Addendum

Addendum Number:	ADD-03
Addendum Date:	02.09.21
Project Number:	20-035
Project Name:	Public Works Vehicle Storage Addition
Owner:	City of St. Charles, MO

3A / A2.4 FLEET SERVICE BUILDING - FLOOR PLAN AREA B

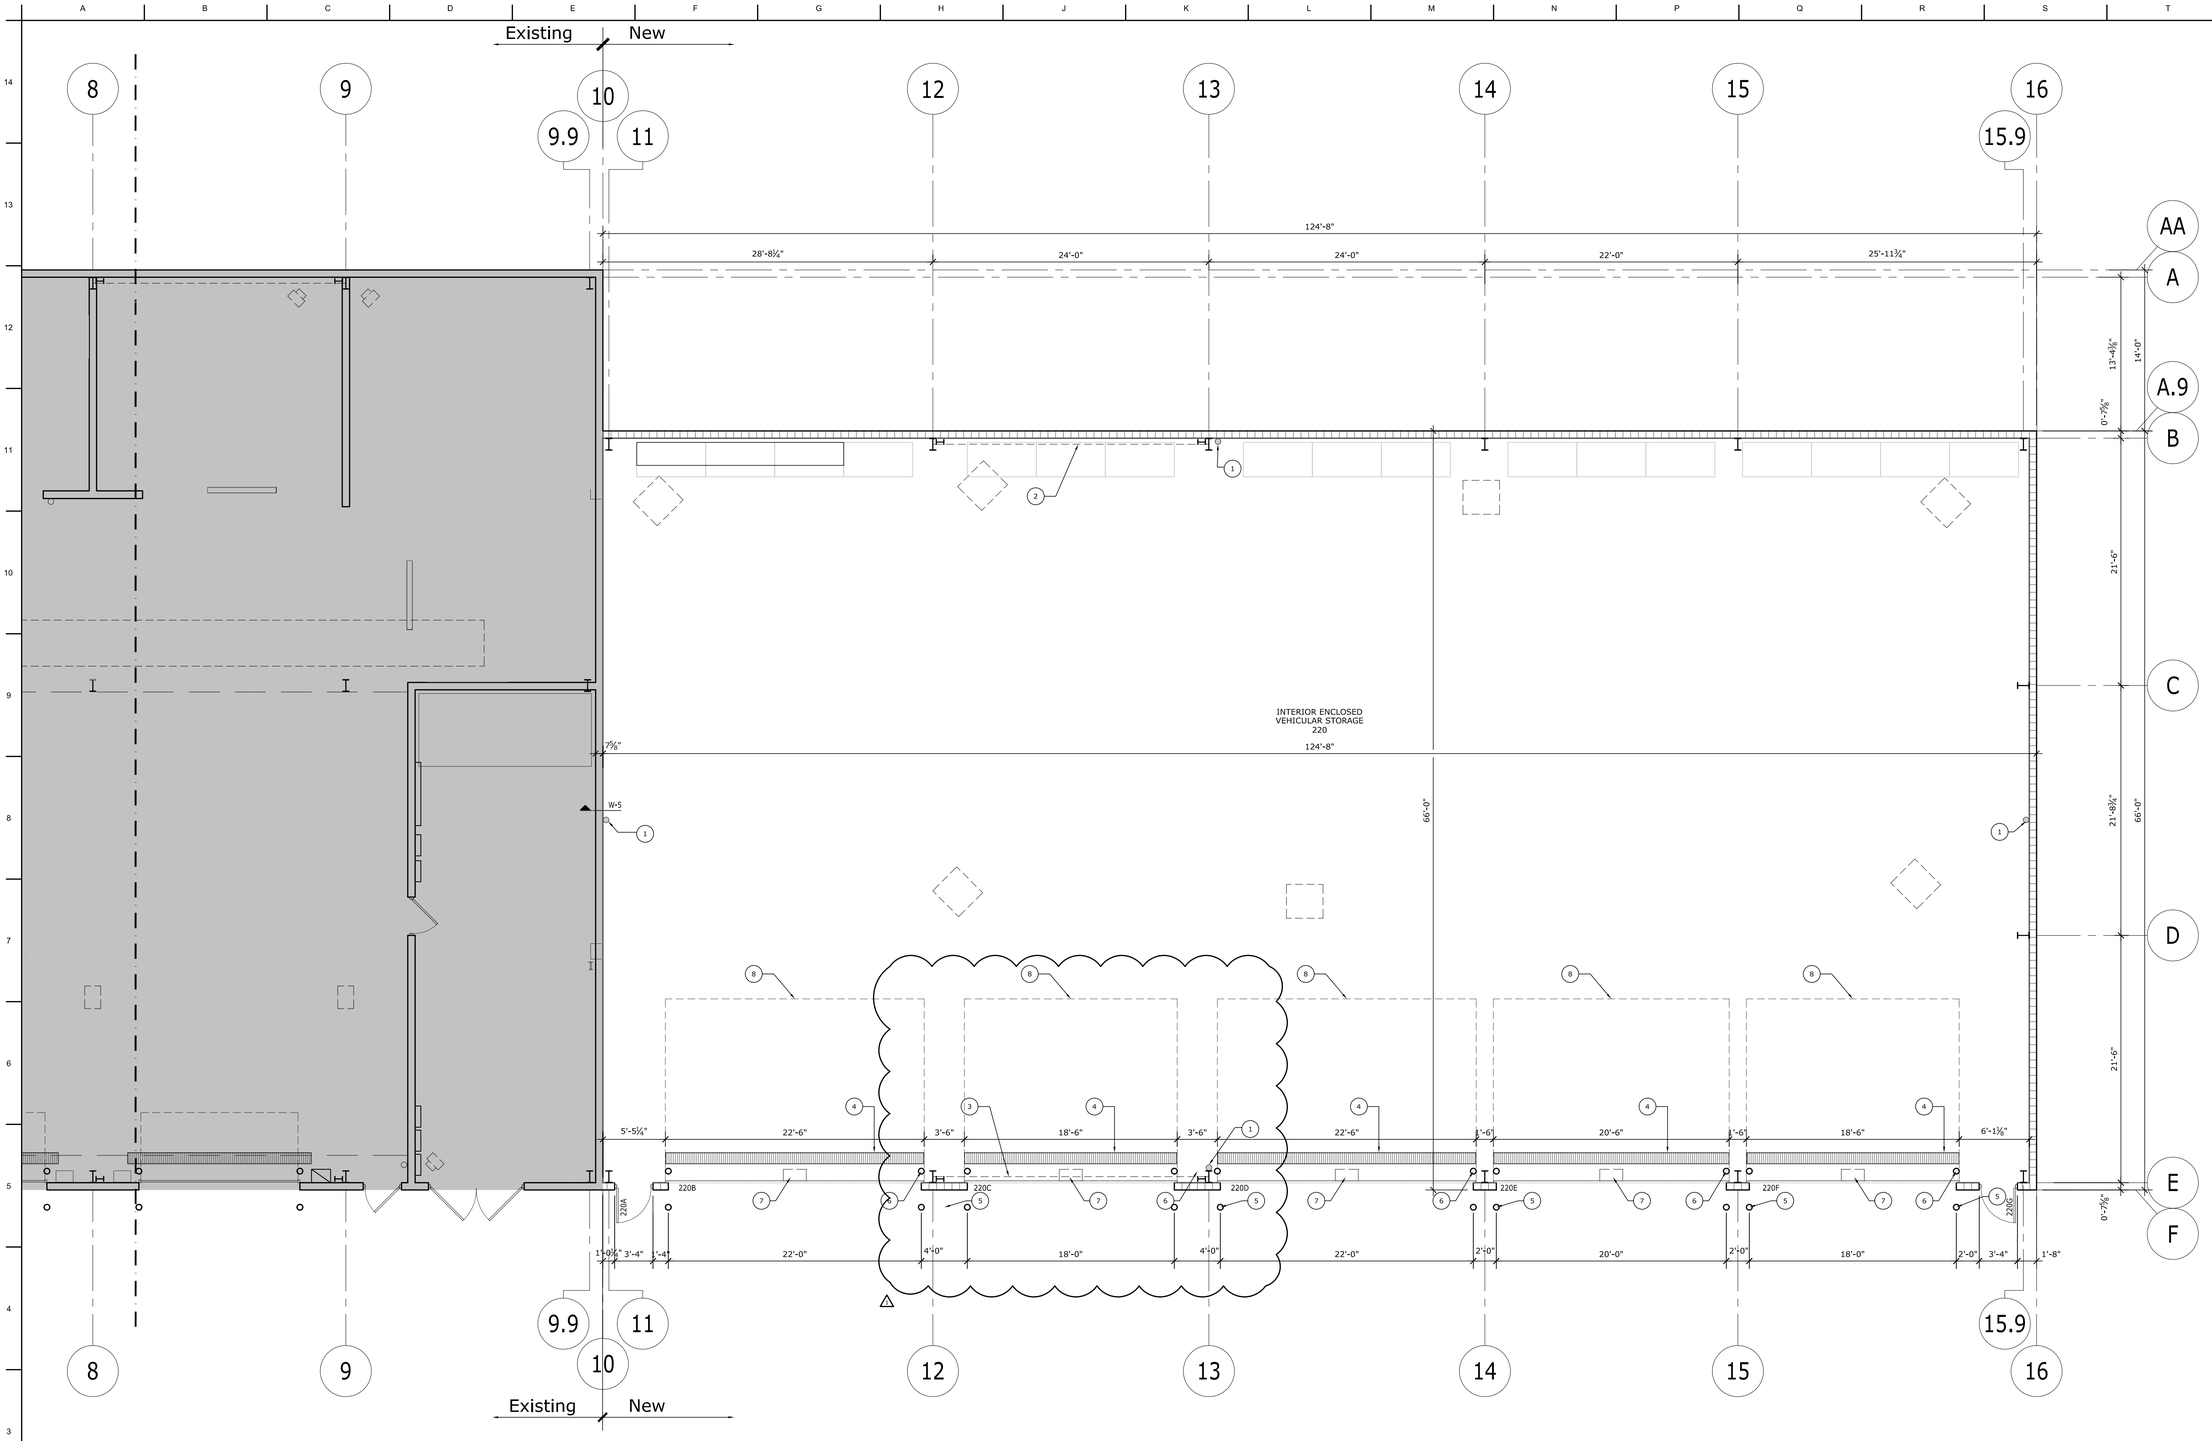
a. Revised width of overhead door 220C

SHEET
A4.4

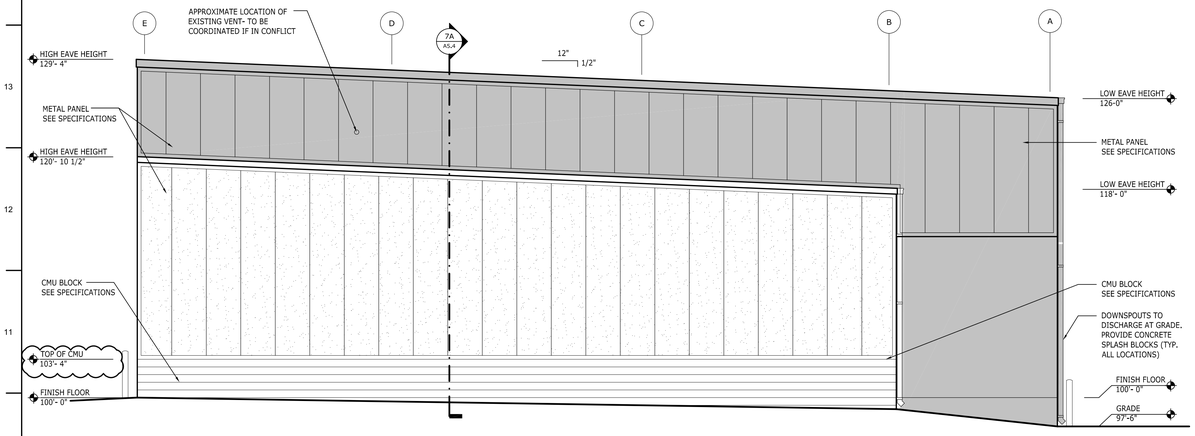
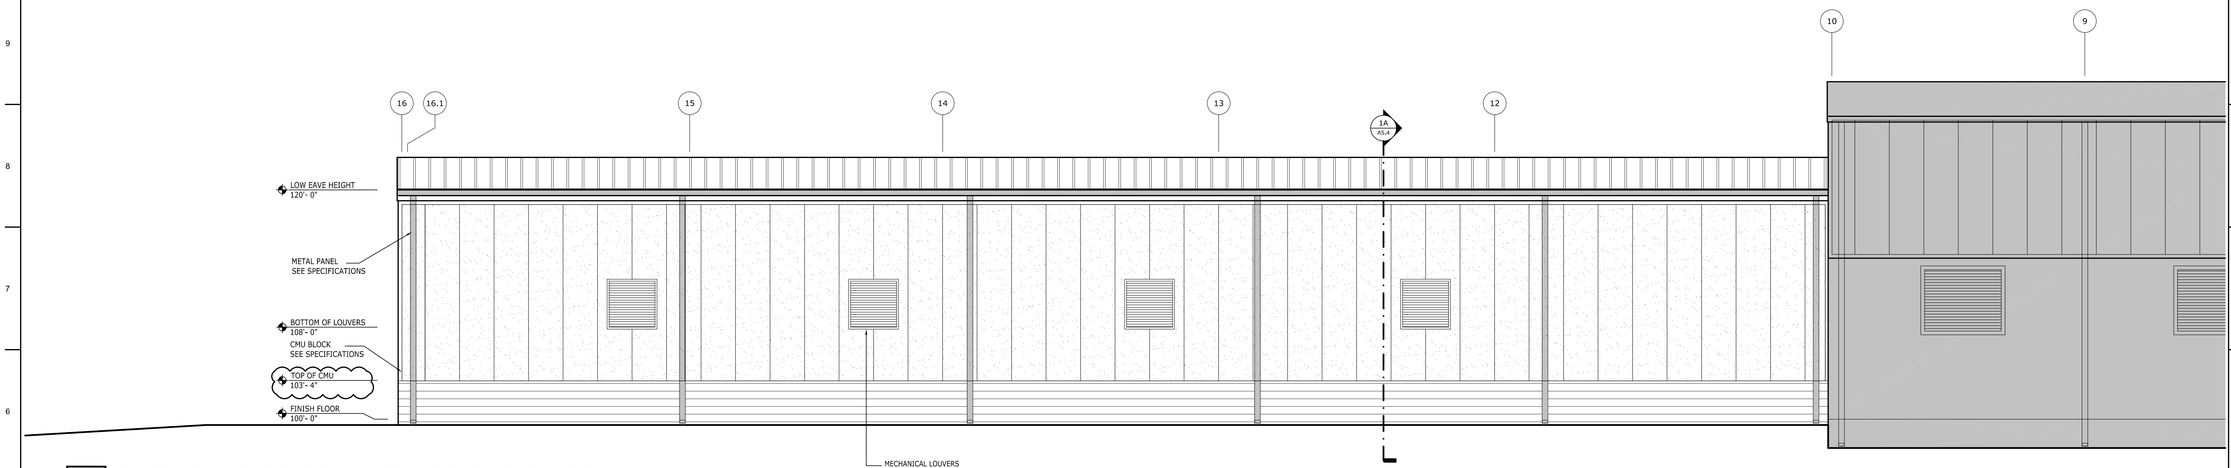
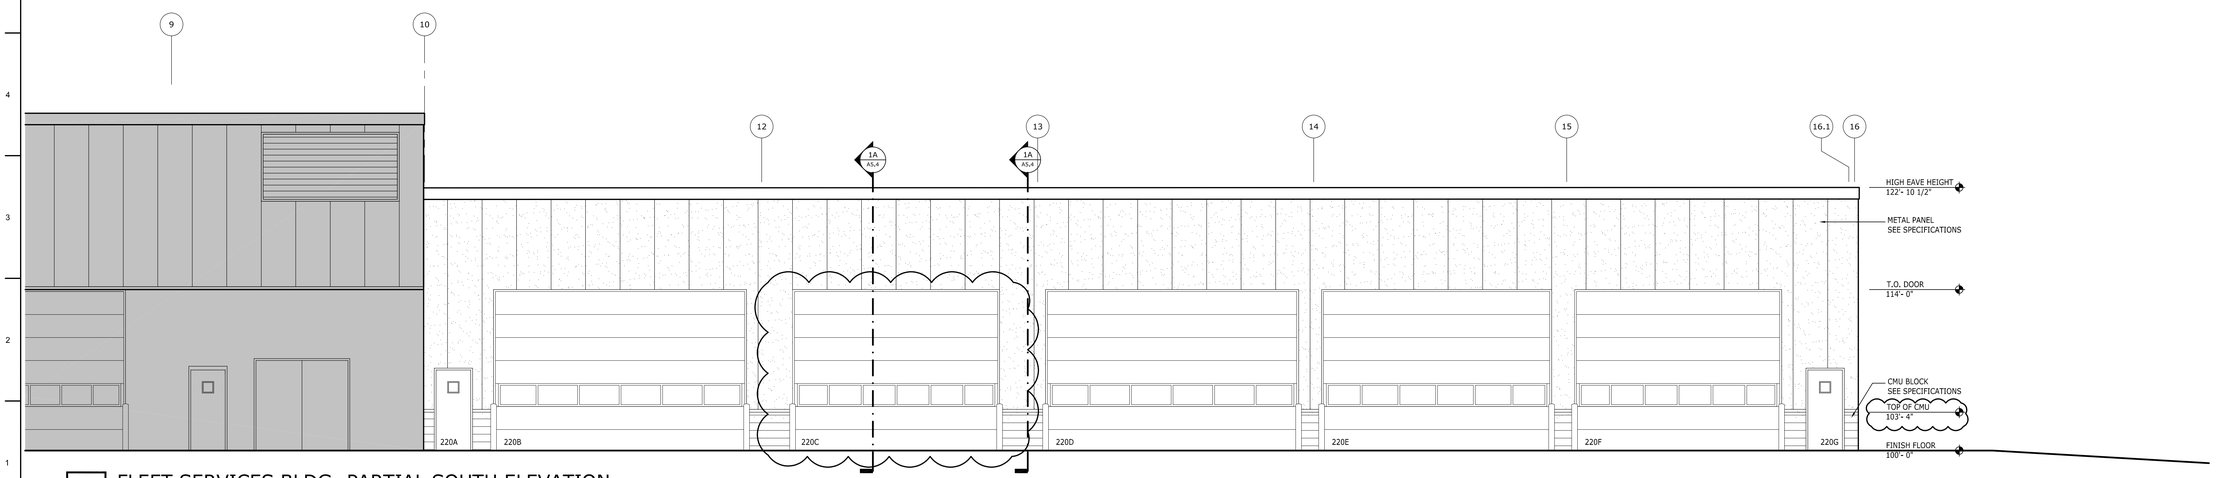
8. A4.4 Vehicle Storage Exterior Elevations
   a. Revised width of overhead door 220C
   b. Revised Top of CMU tag heights to match sections

SHEET
A6.3

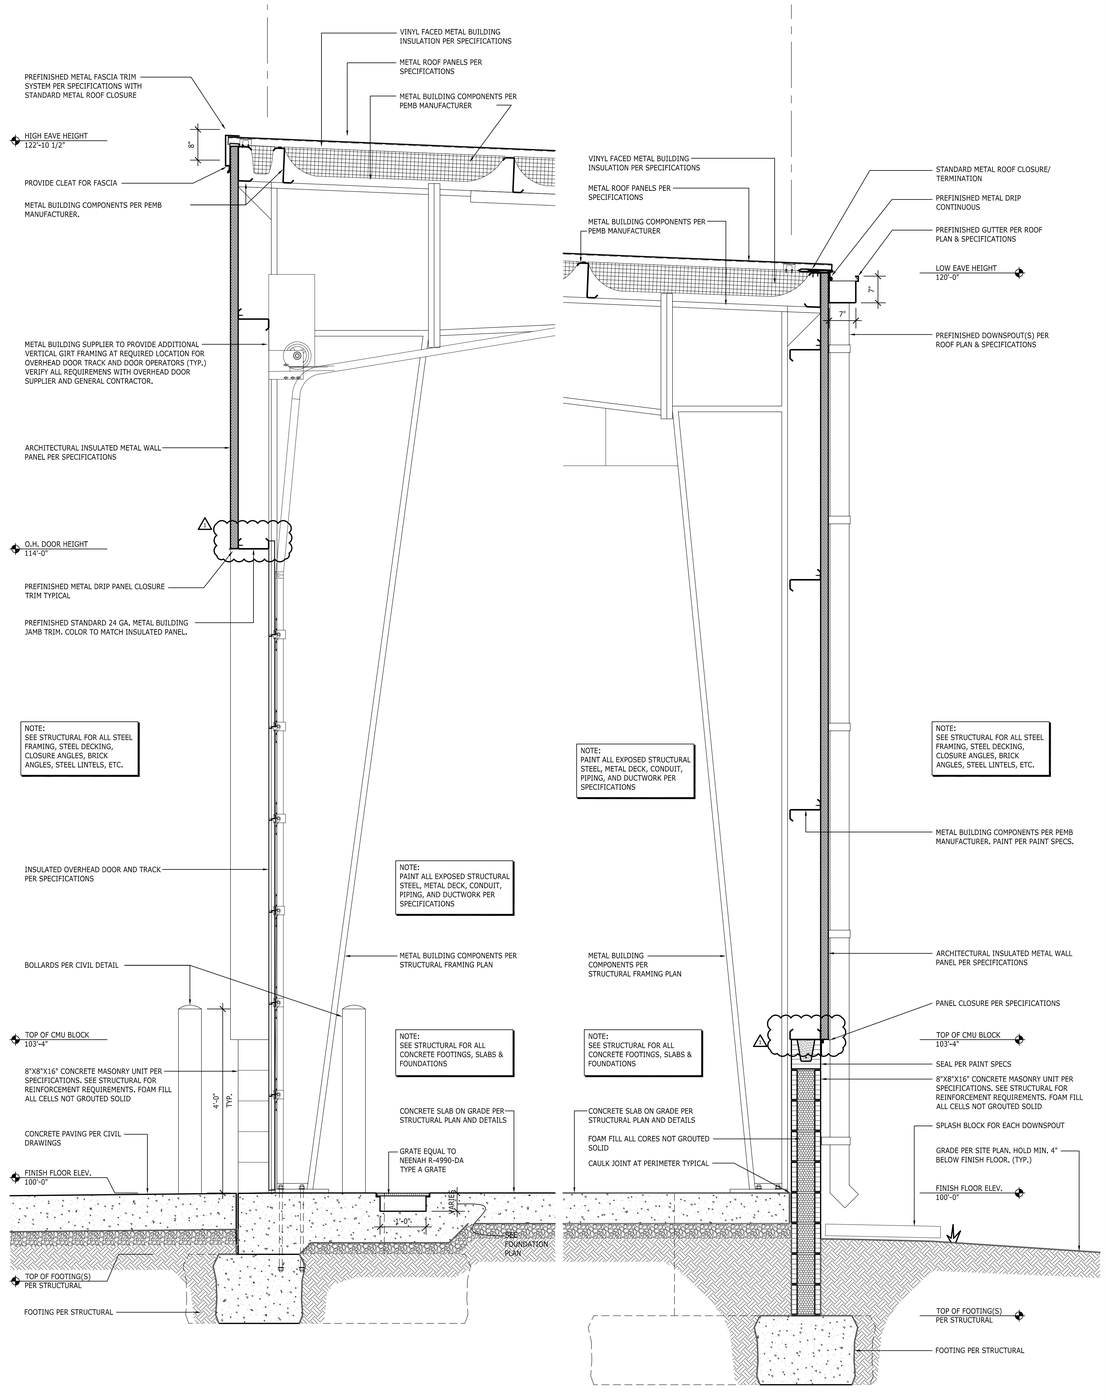
9. A6.3 Wall Sections Vehicle Storage
   a. Removed beams to match structural details

1 ELECTRICAL SITE PLAN
SCALE: 1" = 30'-0"

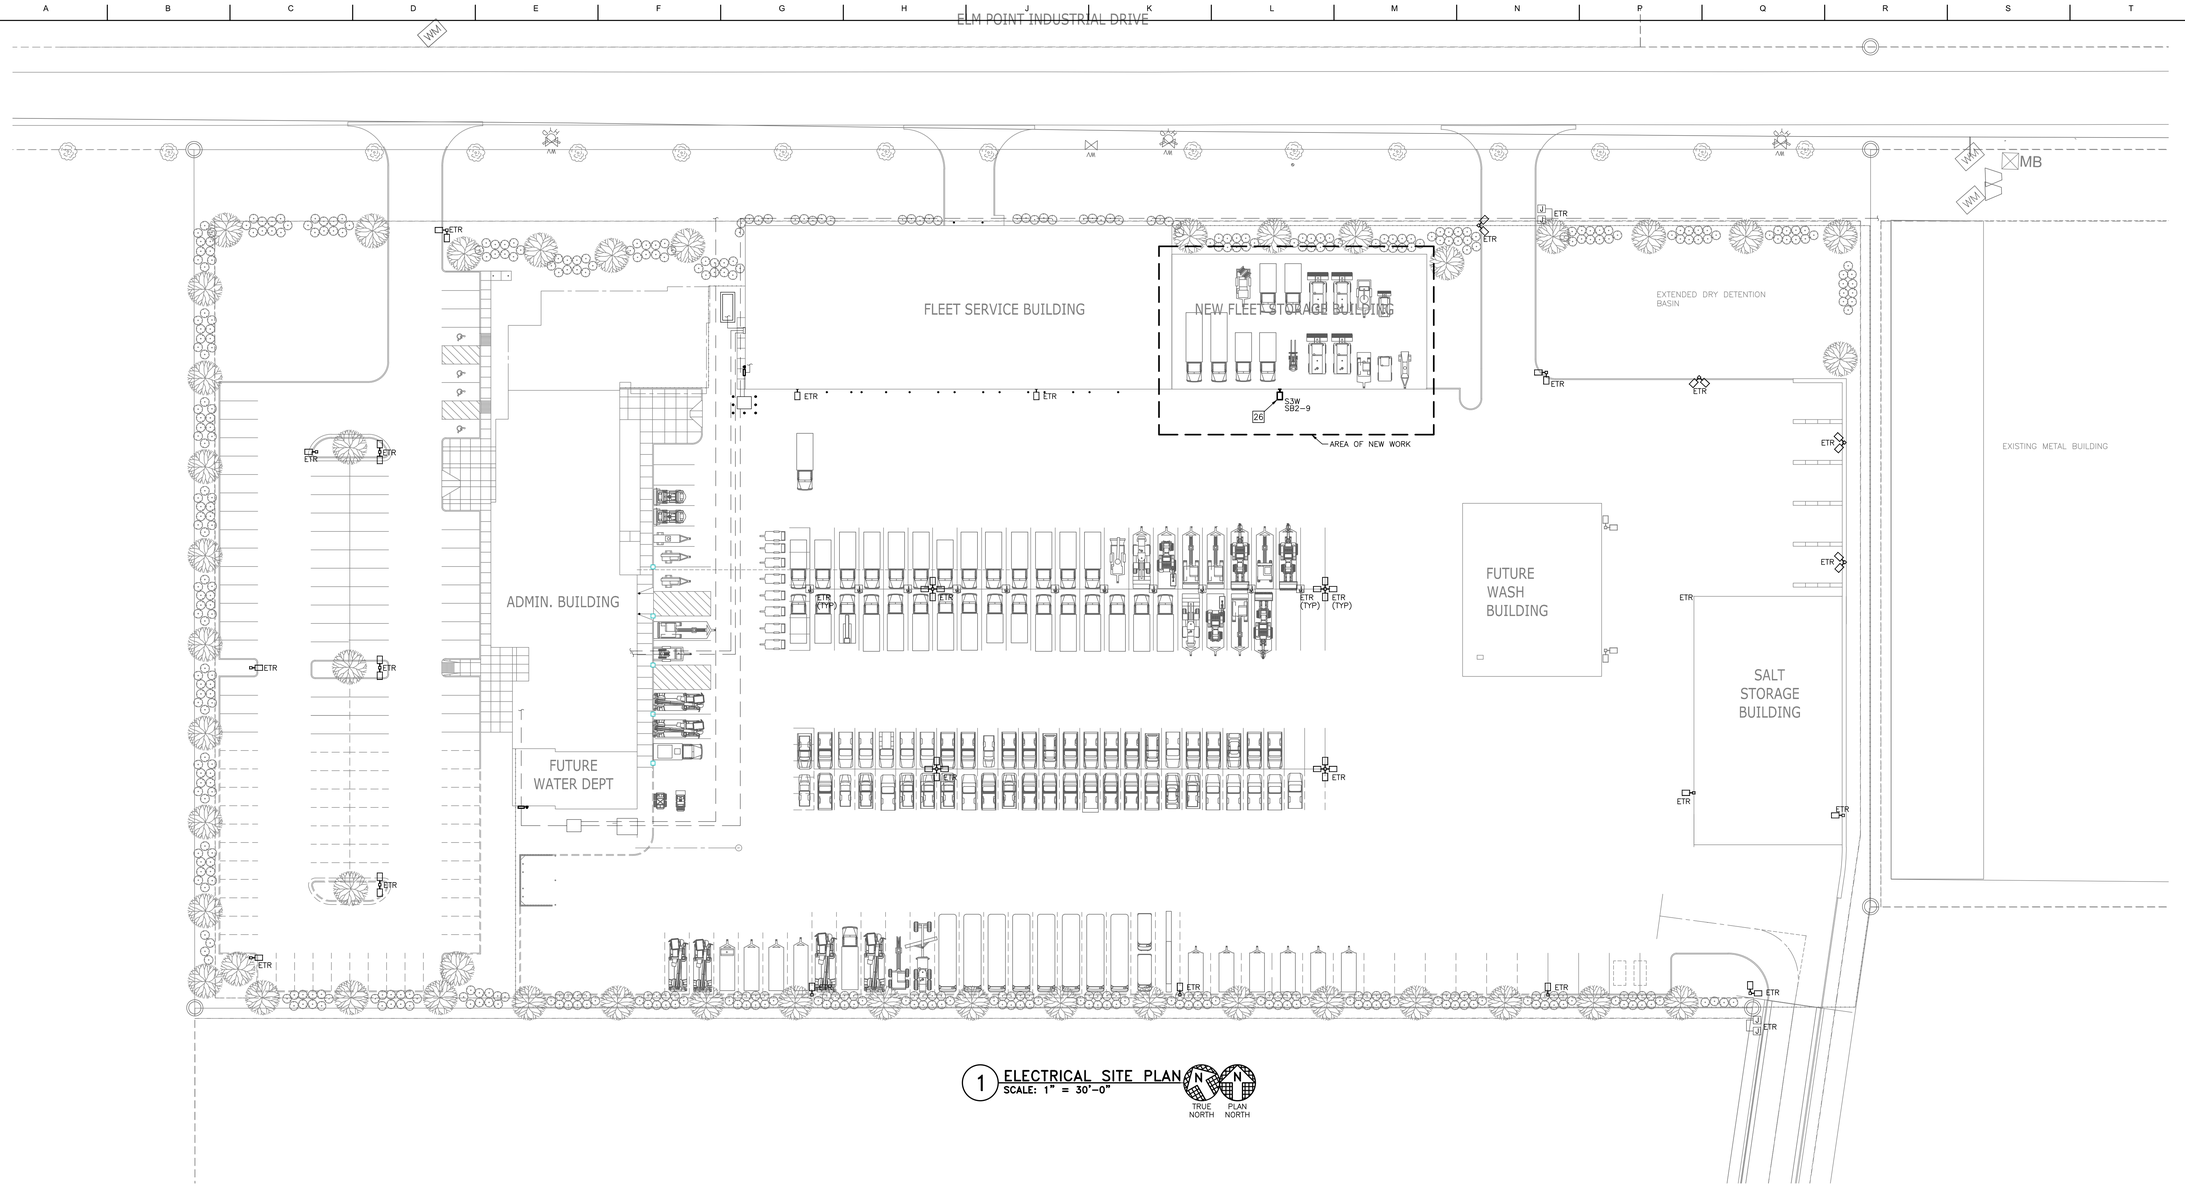
13. E0.1 Electrical Site Plan
    a. CLARIFICATION: Updated plan note E26 clarify that the contractor is to remove the existing light pole and fixture in that location, and install a new building mounted light.

013	Closed	2/2/2021	EMAIL	[redacted]	Is pole light east of existing building ETR or part of demo?	Remove existing pole light located near new S3W fixture location. New building mounted S3W fixture will replace this functionality. Salvage pole and fixture for Owner.	2/4/2021	Dav Bettenhausen, Henderson Engineers Joe Sweitzer, Navigate Building Solutions	Adden 2
014	Closed	2/2/2021	EMAIL	[redacted]	E2.4, what is the 'r' symbol at each man door?	Low voltage light switches to control lights in the building.	2/4/2021	Dav Bettenhausen, Henderson Engineers	Adden 2
015	Closed	2/2/2021	EMAIL	[redacted]	E0.1, there is a 26, like a keyed note reference called out in area of new work but there aren't keyed notes on this page.	Refer to "ELECTRICAL SITE PLAN NOTES" at lower left portion of sheet. E26: BUILDING MOUNTED PARKING LOT LIGHT FIXTURE TYPE "S3W". CONNECT TO EXISTING CIRCUIT SERVING EXISTING TYPE "S3W" FIXTURES MOUNTED TO EXISTING FLEET SERVICES BUILDING.	2/4/2021	Dav Bettenhausen, Henderson Engineers	Adden 2

26 REMOVE EXISTING LIGHT POLE IN THIS LOCATION. PROVIDE NEW BUILDING MOUNTED PARKING LOT FIXTURE TYPE "S3W". CONNECT TO EXISTING CIRCUIT SERVING TYPE S3W FIXTURES. MOUNTED TO EXISTING FLEET SERVICE BUILDING. 1

3 FLEET SERVICE BUIIDING GARAGE DOOR POSITION / MASTER CONTROL SYSTEM - ETR
NO SCALE

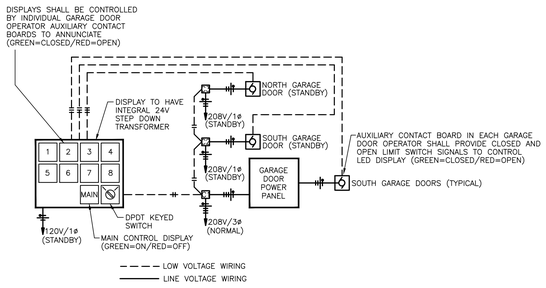
14. E5.1 Electrical Schedules and Details
    a. CLARIFICATION: Detail 3- Added text indicating that the Fleet Service Building Garage Door Position/Master Control system is ETR.

2 FLEET STORAGE BUIIDING GARAGE DOOR POSITION / MASTER CONTROL SYSTEM
NO SCALE

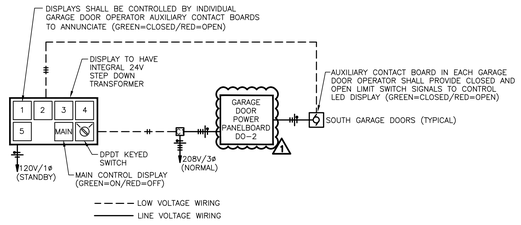
b. CLARIFICATION: Detail 2 – Added text clarifying that Garage Door Power Panel is existing Panelboard DO-2.

025	Closed	2/3/2021	EMAIL		Also, in reference to Sheet E5.1 are the (2) Garage Door Power Panels existing or new? Who is supplying these, and will the electrical contractor be responsible to install them?	GARAGE DOOR POWER PANEL IS THE LINE VOLTAGE PANELBOARD. IN THIS CASE, PANELBOARD DO-2.	2/4/2021	Dav Bettenhausen, Henderson Engineers	Adden 2
026	Closed	2/3/2021	EMAIL		In reference to Sheet M1.6, Where is the existing BAS panel located?	Existing BAS panel is located in the adjacent Fleet Maintenance Building within Storage room 202. It is the southwest corner of the existing building.	2/4/2021	Dav Bettenhausen, Henderson Engineers	Adden 2

3 INTAKE LOUVER INSTALLATION DETAIL
NO SCALE

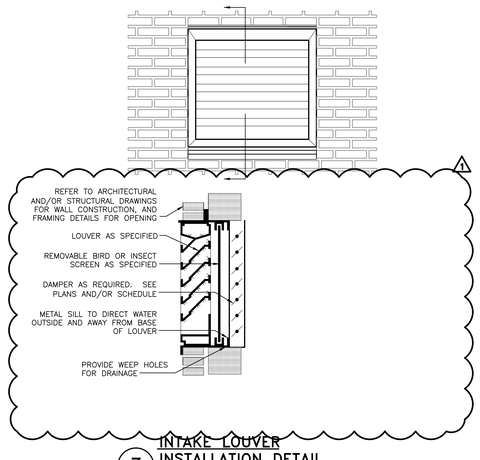
10. M1.6 Detail 3 – Intake Louver Installation Detail
    a. CLARIFICATION: Removed ductwork connections to match conditions of proposed project.
11. M1.6 Detail 2 – Exhaust Fan Control Diagram

SHEET
M1.6

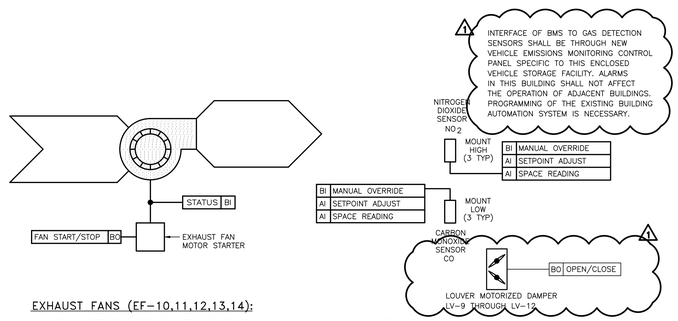
a. CLARIFICATION: Added graphics for louver damper control to match written sequence of operation and plan notes.
    b. CLARIFICATION: Added note clarifying relationship of the new gas detection system to the existing control system and existing building.
